**RESPONSES TO THE US EPA AND OHIO EPA COMMENTS ON THE
WORK PLAN, GEOTECHNICAL SAMPLING AND TESTING AT THE
SOLID WASTE LANDFILL AND PROPOSED ON-SITE WASTE
DISPOSAL CELL FOR OPERABLE UNIT 2**

03/09/94

DOE-1118-94
DOE-FN EPA
11
RESPONSES

FEMP SITE MAP

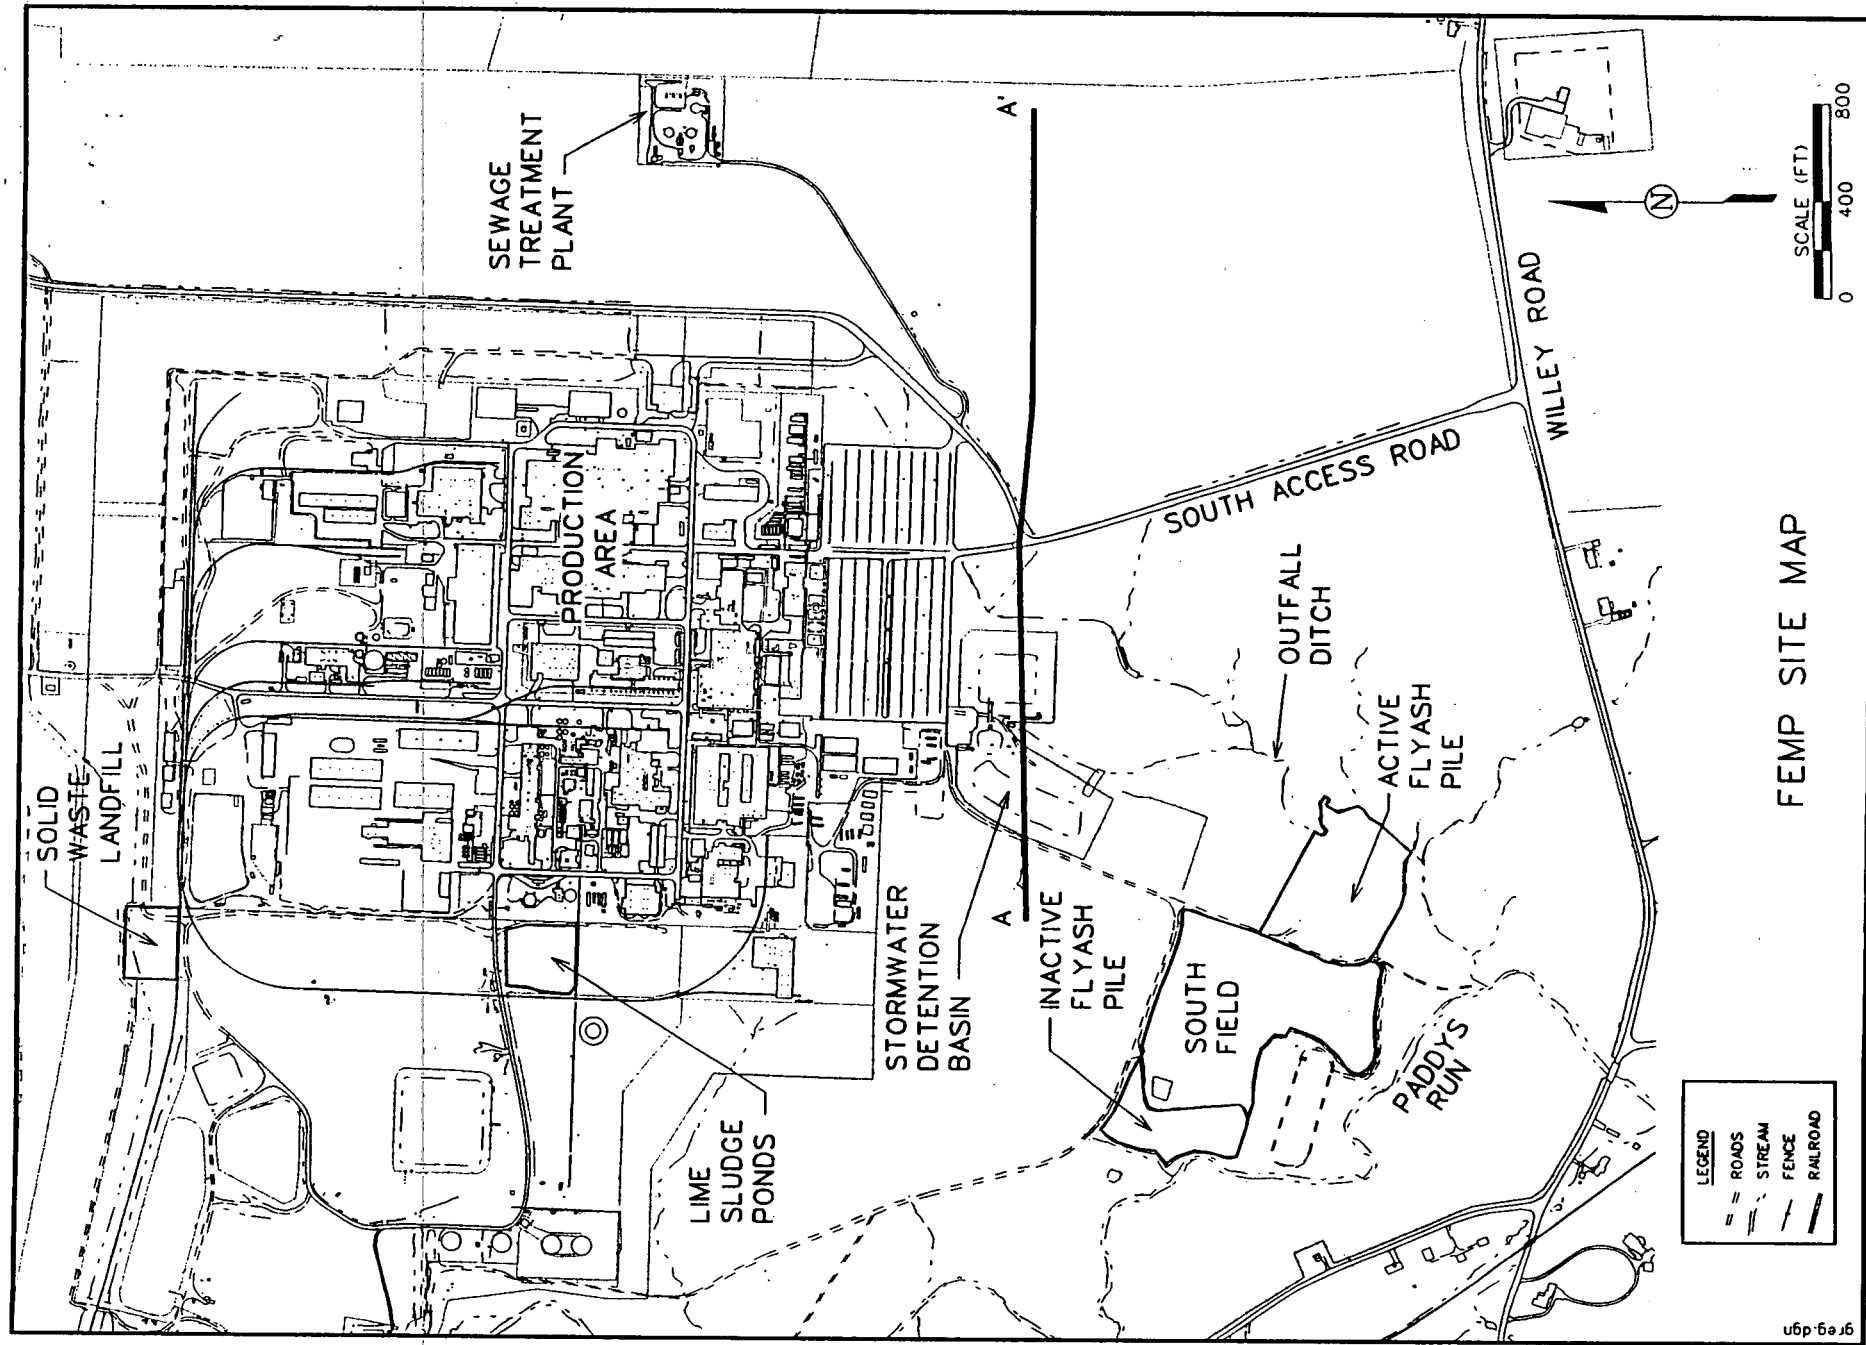
Comment: Task 2, Figure 1A. Thick sand deposits were encountered during the construction of the storm water retention basin. Where do these deposits terminate to the east, in relation to the proposed cell for OU-2 wastes?

Response: The lateral extent of the thick sand lens encountered in the stormwater retention basin terminates approximately 1200 feet west of the proposed disposal cell. The attached plan and cross-section show the extent of known sand deposits in the disposal cell area.
